Informal document No. GRE-65-31
(65th GRE, 28-31 March 2011,
agenda item 5(f))

Angular specifications for courtesy and manoeuvring lamps to

ECE/TRANS/WP.29/GRE/2011/29

Submitted by the Chair of the task force on courtesy lamp

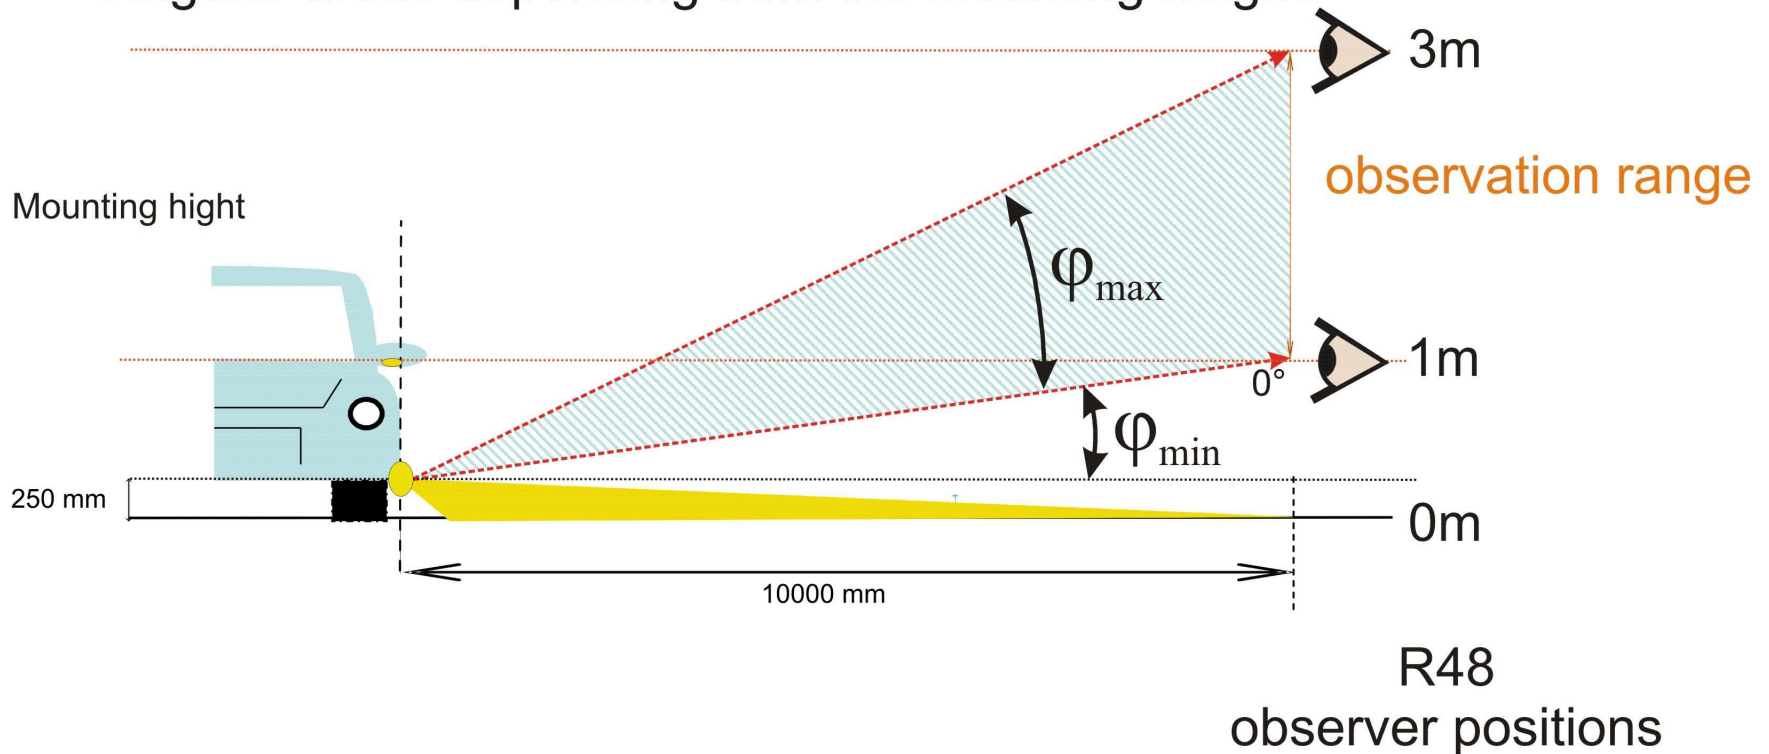
There is a mistake in paragraph 6.2.1.

Insert new paragraphs 6.2 to 6.3.3., to read:

"6.2. Intensity of the light specifications for exterior courtesy lamps

6.2.1. The intensity shall be not larger than [500] candelas in the angular field ~~defined in para 6.2.3~~ when installed in any mounting position specified by the applicant

Tolerance areas depending from the mounting height

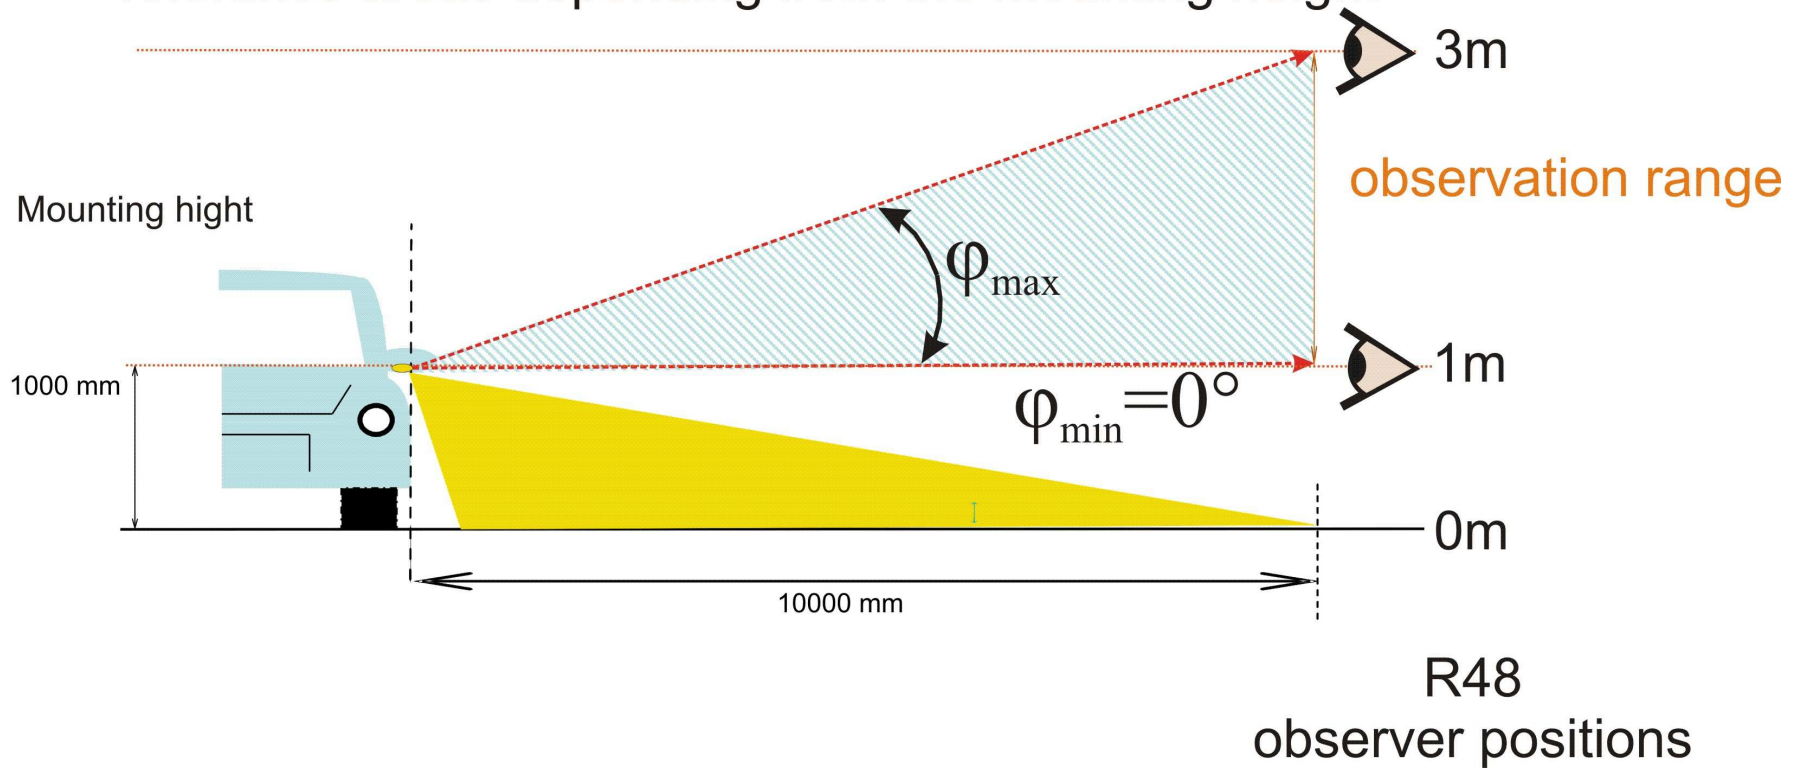
$$\varphi_{\min} = \arctan \left(\frac{1 - \text{mounting height}}{10} \right); \text{ with the mounting height in m}$$

$$\varphi_{\min} = \arctan \left(\frac{1 - 1}{10} \right) = \arctan (0) = 0^\circ$$

$$\varphi_{\min} = \varphi_{\max} + 11,3 = 0 + 11.3 = 11.3^\circ$$

$$\tan(11.3) = 0.1998 \rightarrow h = 0.1998 \times 10000 = 1998 + 1000 = 3989 \rightarrow \approx 3\text{m}$$

Angular areas depending from the mounting height

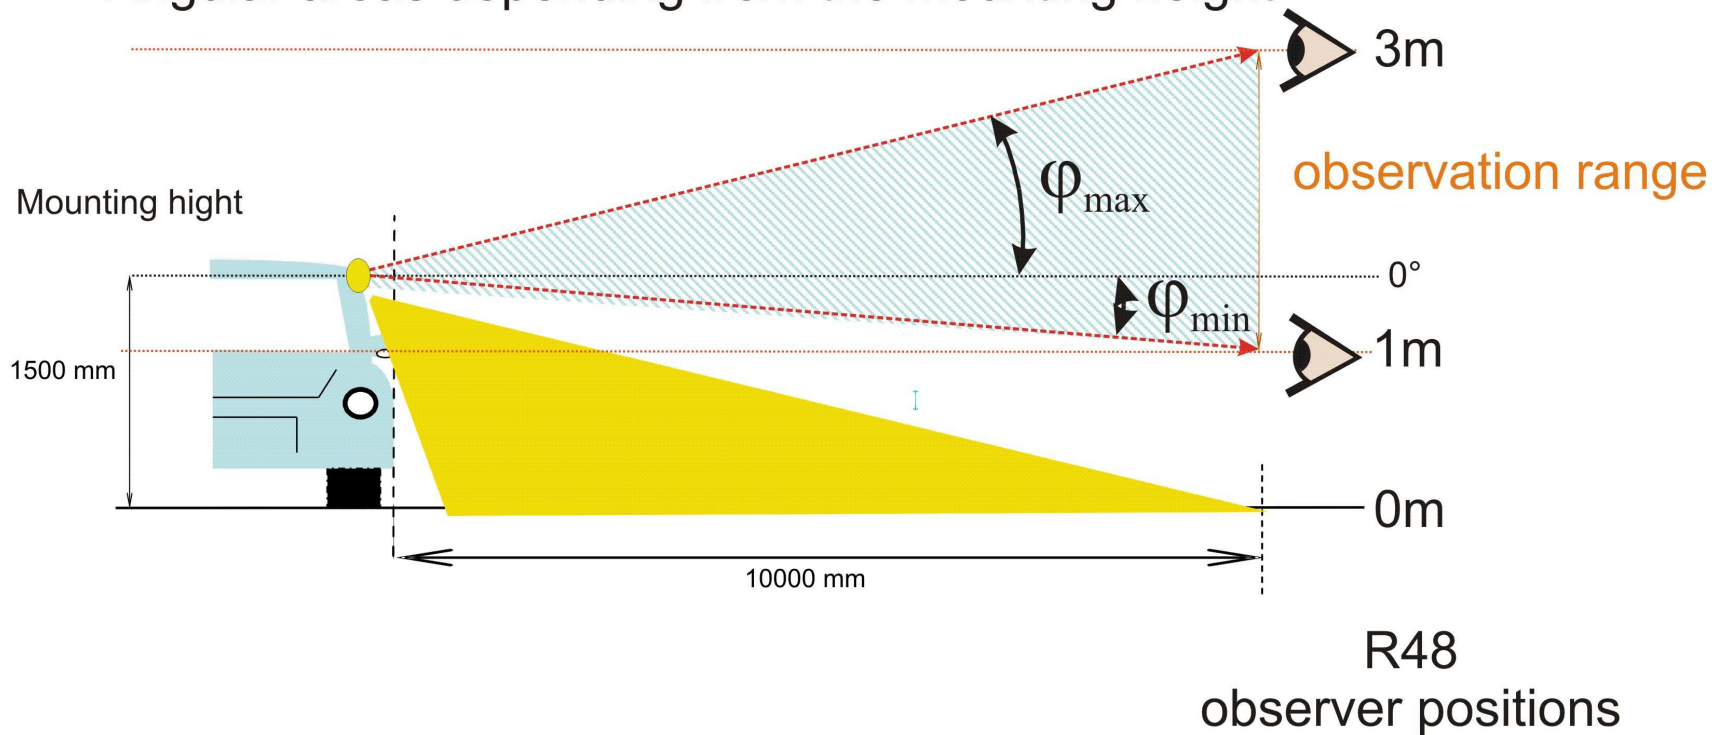
$$\varphi_{\min} = \arctan \left(\frac{(1 - \text{mounting height})}{10} \right); \text{ with the mounting height in m}$$

$$\varphi_{\min} = \arctan \left(\frac{(1 - 1.5)}{10} \right) = \arctan (-0.05) = -2.87^\circ$$

$$\varphi_{\min} = \varphi_{\max} + 11,3 = -2.87 + 11.3 = 8.43^\circ$$

$$\tan(8.43) = 0.1482 \rightarrow h = 0.1482 \times 10000 = 1482 + 1500 = 2982 \rightarrow \approx 3\text{m}$$
